**Re: Defect Information Report – Supplemental Report No. 1
11V-465, FL-612, Meritor WABCO Electronic Stability Control
System
Dealer Interim Notification**

November 2011
FL612
NHTSA #11V-465
Transport Canada #11-346
INTERIM RECALL BULLETIN

Subject: Meritor WABCO Electronic Stability Control Systems

Fig. 2, ESC Module Connection

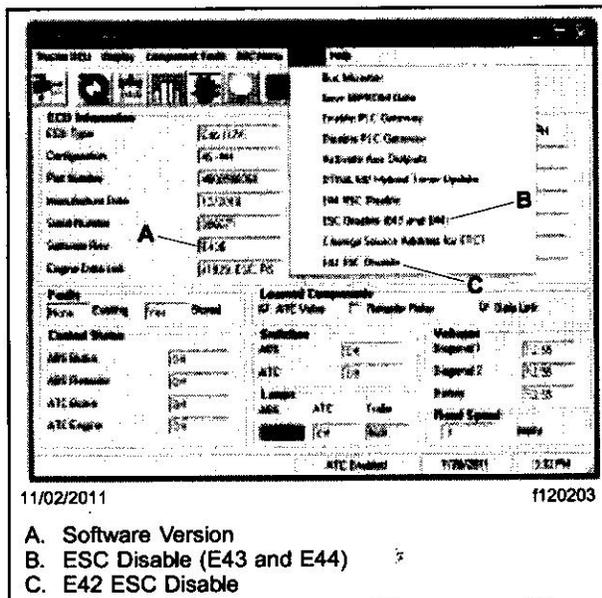
A dialog box will appear indicating that ESC has been disabled.
5. Exit Toolbox and turn the ignition OFF for at least 5 seconds.
6. If the software rev. is E43 or E44, go to step 10 in these work instructions.
7. If the software rev. is E404, disconnect the wire harness connected to the ESC module, and tape the end to protect the connector. Coil the harness, and secure it to the frame. See Fig. 2.

Fig. 1, Accessing ESC Disable in Meritor Toolbox

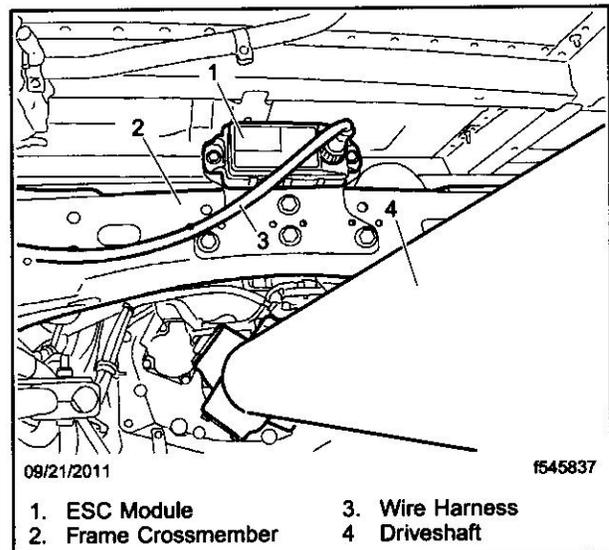
The software version is displayed in a box in the "ECU Information" section, and is labeled "Software Rev." See Fig. 1.
 - 3.3 Write down the first three or four characters of the software rev. number (e.g., E43 or E404).
4. Using Meritor Toolbox, disable the ESC.
 - 4.1 Simultaneously press CTRL, ALT, SHIFT, and F12. A menu item titled "Utility" will appear.
 - 4.2 Click on "Utility"; a drop down menu will appear. See Fig. 1.
 - 4.3 If the software rev. is E43 or E44, select "ESC Disable (E43 and E44)."
 - 4.4 If the software rev. is E404, select "E42 ESC Disable."

Fig. 3, SAS Connection (Cascadia and Columbia)

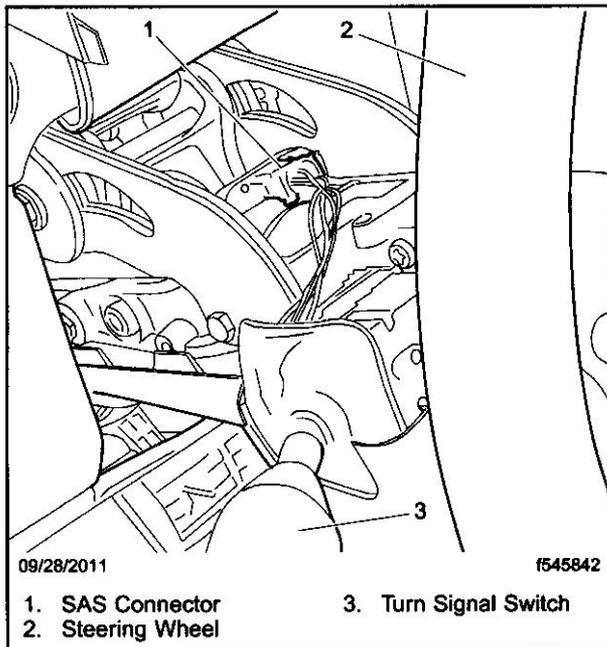
8. If the software rev. is E404, disconnect the steering angle sensor (SAS) harness. Follow the instructions below for the vehicle being serviced.
 - 8.1 On Cascadia and Columbia vehicles, tilt the steering column to its lowest position, then remove the upper steering column cover to access the SAS. See Fig. 3.
On Business Class M2 vehicles, remove the lower steering column cover to access the SAS. See Fig. 4.
On A-Line vehicles, the SAS is on the underside of the steering column just above the U-joint. See Fig. 5.
 - 8.2 Disconnect the 7-pin connector from the SAS. Secure it away from any moving parts.
 - 8.3 Install any steering column covers that were removed.
9. Check for fault codes. If any related fault codes are present, clear them.
10. Make a copy of the warning notice that identifies roll stability has been deactivated and place it on the driver side dashboard of the vehicle.
